UNITED STATES PATENT AND TRADEMARK OFFICE

APPLICATION NO.	FILING DATE	FIRST NAMED INVENTOR	ATTORNEY DOCKET NO.	CONFIRMATION NO.
10/751,565	01/05/2004	Masaaki Ueda	17339	3667

Office Action Summary	Application No. 10/751,565	Applicant(s) UEDA ET AL.	
	Examiner Henry M. Johnson, III	Art Unit 3739

FIG. 1

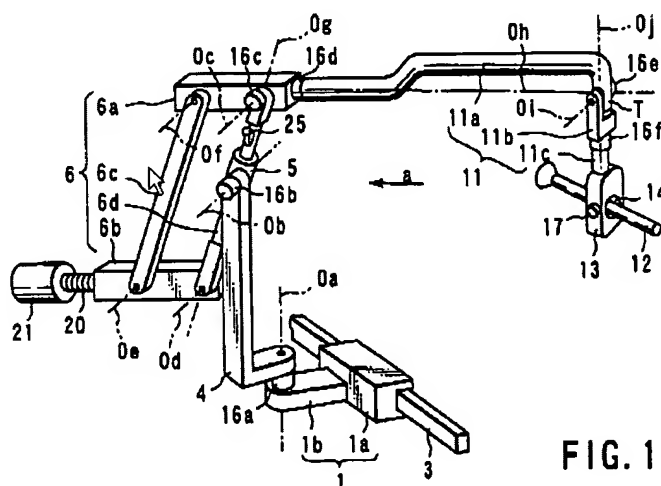
Shimmura et al. teach a medical instrument holding apparatus with a portion for holding an instrument (Fig. 1, #

14), a support arm (Fig. 1, # 11a), a base support (basal portion, Fig. 1, #s 3 & 4), a shaft coupled to the basal support (Fig. 1, # 5), the shaft forming part of a parallelogram moving (moving mechanism) structure (Fig. 1, # 6) with a counterweight (Fig. 1, # 21) to offset the weight of the support arm (Fig. 1, # 11a) and instrument. The mechanism is rotatable about axis 0g (Fig. 1). Arm 6a is clearly shorter than arm 6c of the parallelogram. A ball joint is disclosed that connects the moving portion to an instrument support portion (Fig. 7, #16h). Since the center of gravity of the instrument and support depends on the instrument and the orientation, the ball joint is clearly capable of being oriented in any relation to the center of gravity. An operator may grasp any portion of the support and instrument elements.

(Fig. 1, #s 16a-16f), with an activating switch on the holding portion (paragraph 0059). A braking means is also disclosed for the ball joint (paragraph 0092). The instrument holding portion is interpreted is capable of being held by an operator and is coupled to the support arm by rotatable joints (Fig. 1, #s 16e & 16f). The upper portion of the parallelogram is shorter than the lower portion with the counterweight and either of the side arms. The counterweight is adjustable via screw threads (Fig. 1, # 20).
